SERVICE BULLETIN

supersedes SB No. 33A

REPLACEMENT OF RUDDER PEDALS

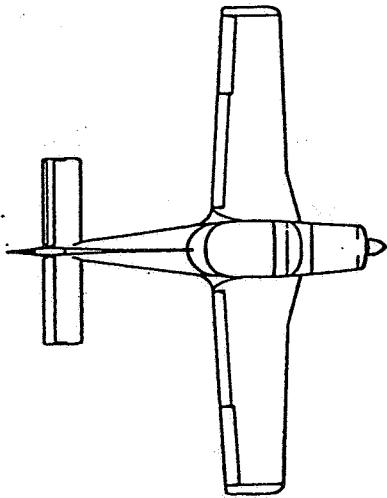
1.2 Reason: Cracked pedal levers

1.3 Contents of this Bulletin: Replacement of pedal assemblies

- #### 1.4 Compliance:
- For serial numbers 2 to 23, 34, 107 to 109, 112, 124, 127, 129, 130, 134, 135 replacement of assemblies at the next 100h inspection, but not later than June 30, 1990
 - For serial numbers 27 to 29, 103 to 106, 110, 111, 114 to 116, 119 to 122, 128, 136 to 223 not later than March 31, 1991

- 1.10 Electric load data: unaffected
- 1.11 Reference to other Publications: Shop Manual, Chapter 27-20-00 (AMM/IPC)
2. Accomplishment Instructions
- 2.1 Preparation:
- Remove control sticks
 - Remove floor plates items 7 and 8 of AMM/IPC, Chapter 53-20-01, Page 0
 - Disconnect cables and rods
- 2.2 Replacement:
- Removal of old pedal assemblies with pedal lever outside dia 17,6 mm
 - Installation of new reinforced pedal assemblies with pedal lever outside dia 20,8 mm
- See AMM/IPC, Chapter 27-20-01, Fig. 02 and 03
- 2.3 Completion:
- Connect and adjust cables and rods
 - Install floor panels
 - Install sticks
- Accomplishment of this SB shall be entered in the Aircraft Technical Log
3. Material
- Torsion tubes 202-16.124 (LH) and 202-16.125 (RH) with reinforced pedal levers may be procured from FFA.
